# BILLET D'ÉTAT

DRAFT AMENDMENT TO THE URBAN AREA PLAN REVIEW No 1  
FOR LEALE'S YARD MIXED USE REDEVELOPMENT AREA

**AMENDMENTS TO FIGURES WITHIN THE OUTLINE PLANNING BRIEF**

## **Draft Outline Planning Brief Leale's Yard Mixed Use Redevelopment Area**

## FIGURE 4 – SECTION 8.3

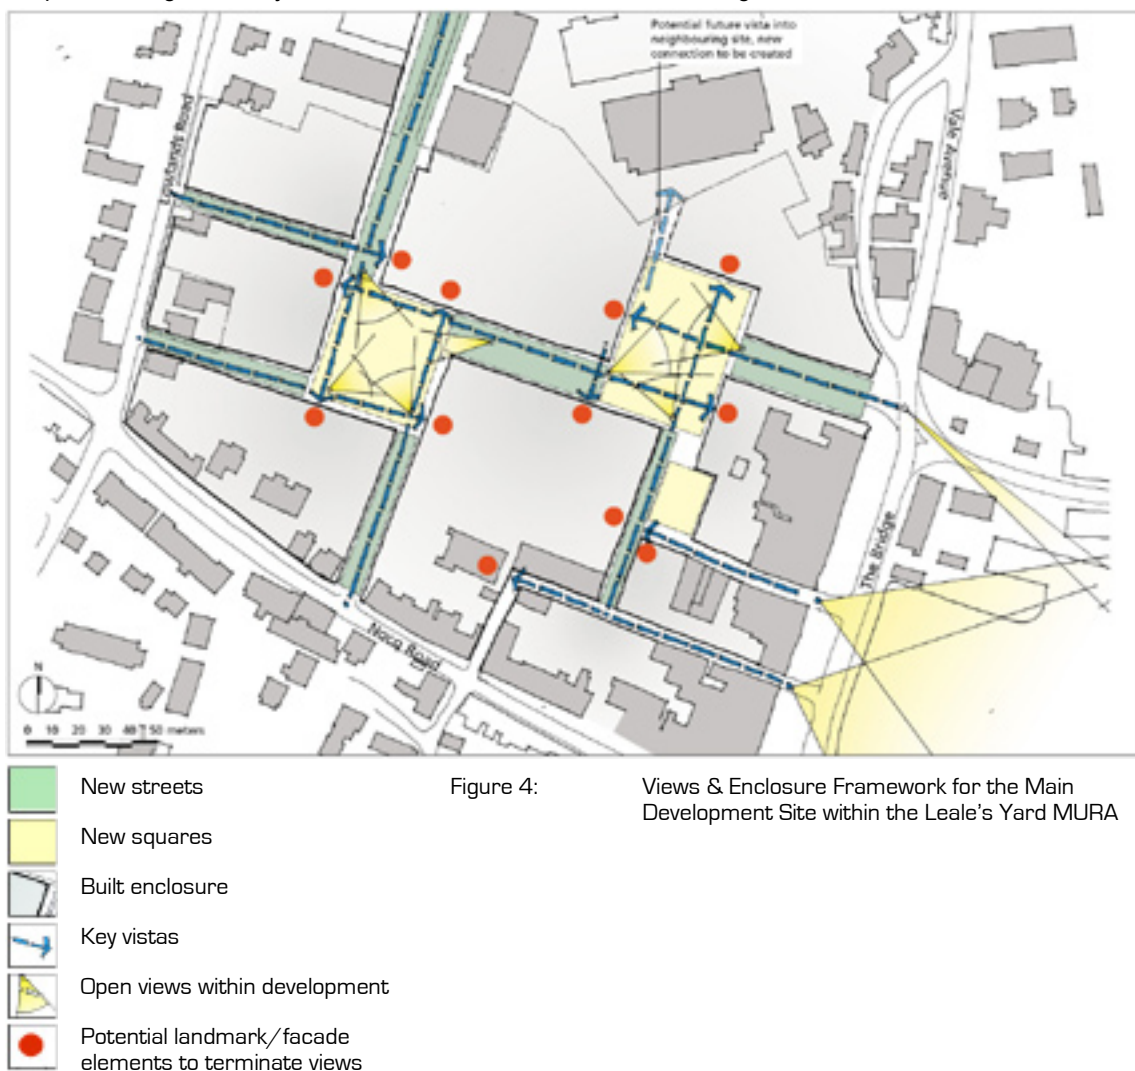
2. Redraw Figures 4, 5 and 8 to 11 so that the urban form in the Main Development Site does not turn its back on later phases.
  3. Delete from the fourth paragraph of Section 9.2 the phrase "particularly for options including the petrol filling station."

28. **I also recommend** that Figures 4, 5 and 8 to 11 be redrawn so that the urban form in the Main Development Site does not turn its back on later phases. It should indicate the desirability of breaks to permit pedestrian and visual flows through into the Oscar and Falles Holdings lands. That would be consistent with Figure 3.

**Emboldened text** relates to criteria that apply specifically, though not exclusively to development within the Main Development Site. Development within the Main Development Site will also be required to satisfy the Department's general objectives for views and enclosure set out in figure 4 below.

## FIGURE 11 – SECTION 9.5

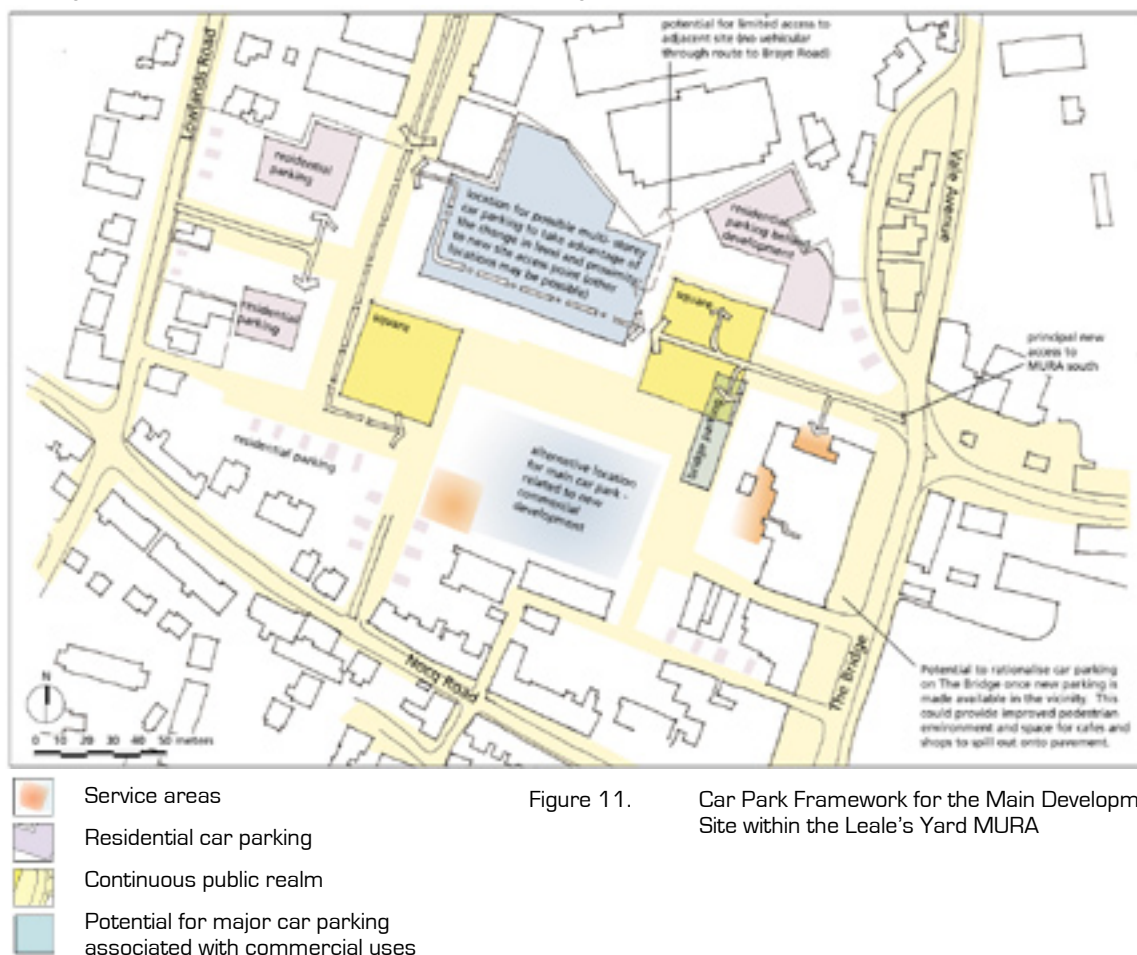
38. The Brief does envisage (in Figure 11) that, as an essential part of the retail and other developments, some limited additional car parking should be provided in a convenient location behind the existing shops linked to new pedestrian orientated routes through to the harbour area. I support that element of the development framework. It will be crucial to the success of this part of the MURA that it is provided early in the phasing of the new uses which would surround it, as a way of integrating the old and the new, both visually and for trade.

**Emboldened text** relates to criteria that apply specifically, though not exclusively to development within the Main Development Site. Development should also satisfy the Department's general objectives for car parking within the Main Development Site, set out in figure 11 below.

Figure 3 below indicates a general development framework, which sets out the Committee's overall urban design objectives for the MURA.

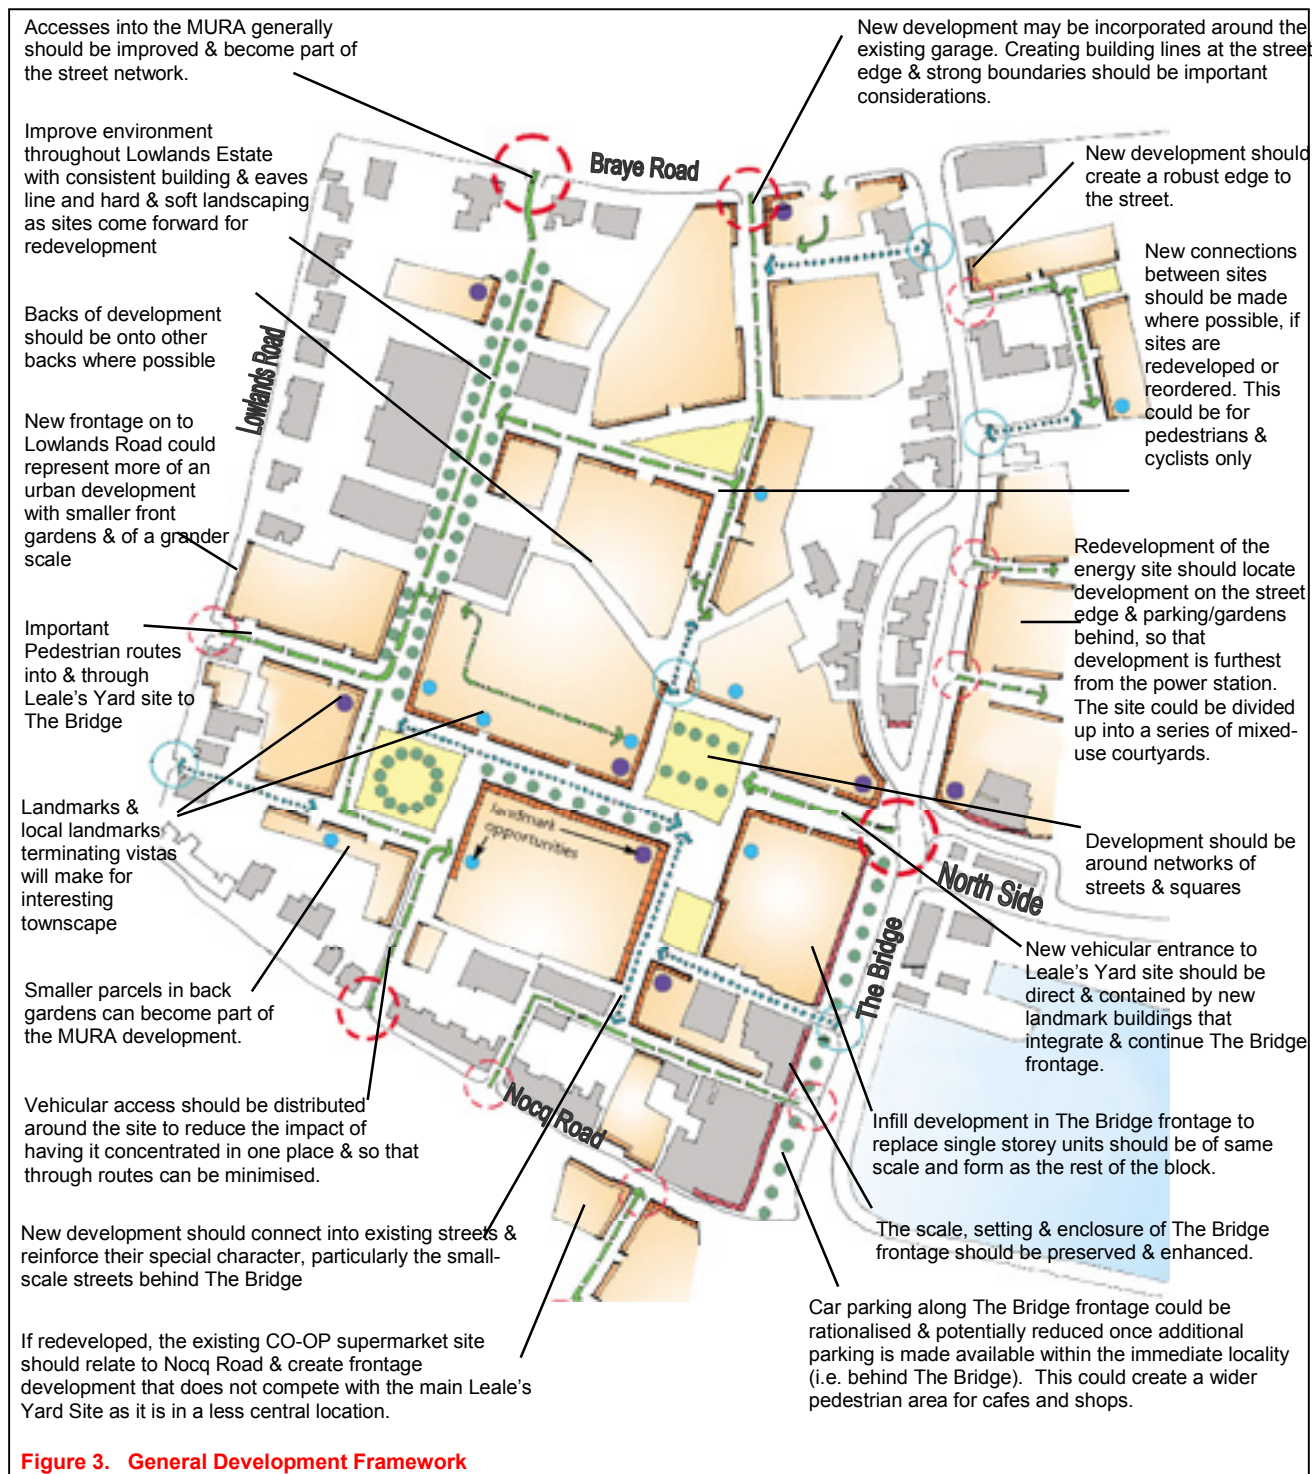
26. **I recommend** that no changes be made to the overall land use and urban design strategy or to Figure 3.
27. It would however give greater weight to the primacy of the overall strategy if a clearer distinction were made in the text in Sections 8.3, 8.4, 8.6, 9.3, 9.4 and 9.5 between the criteria that apply to all development and the more specific objectives for the main development site. **I recommend** that that be achieved graphically rather than by any amendment to the words.

44. Turning to the individual representations, the implications of a greater use of the Lowlands Industrial Estate Road has been discussed above. Although as Mr Brache pointed out, Figure 3 shows by a dotted circle some possible works at the junction with Braye Road, that is an indicative diagram and has no implications for what, if any, changes may eventually be put forward. Miss Bellot & Mr Hubert raised the issue of a service access to the site from beside their home on Nocq Road, which is also shown diagrammatically on Figure 3. That utilises an existing gap, but it will be essential to design it in such way that protects the amenity of the neighbouring homes.

Figure 8: Building Heights Framework for the Main Development Site within the Leale's Yard MURA

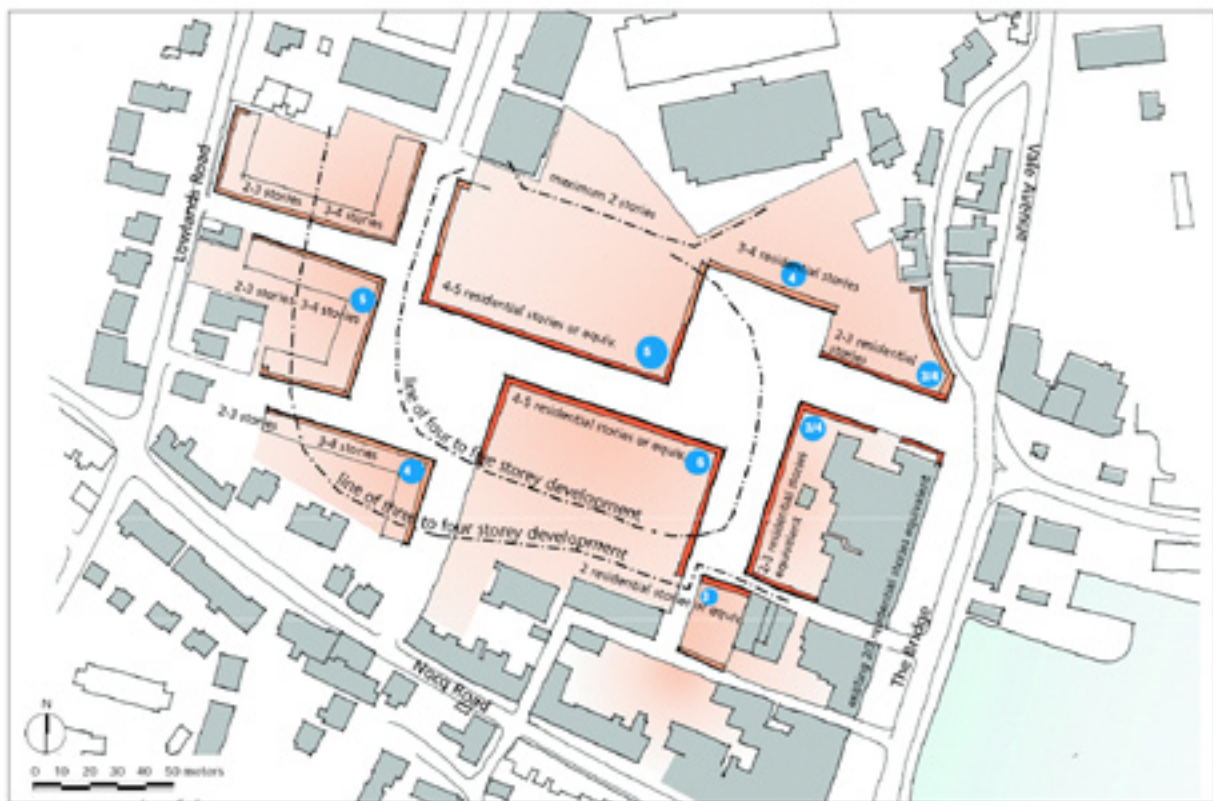
46. Both Mr & Mrs Carre and Miss Bellot & Mr Hubert raise the issue of high buildings and the effect on their homes or on public spaces, as set out in Section 8.6 and Figure 8. There is a balance to be struck between creating a more urban feel to the Main Development Site, using the depth of land and the topography to create a mix of heights and architectural forms – and the effect on amenity. Having looked carefully at the site, I believe that the IDC's approach is right and that building heights of up to four domestic stories in the centre of the site and lower at the edges will both create an interesting urban form and protect residential outlook.
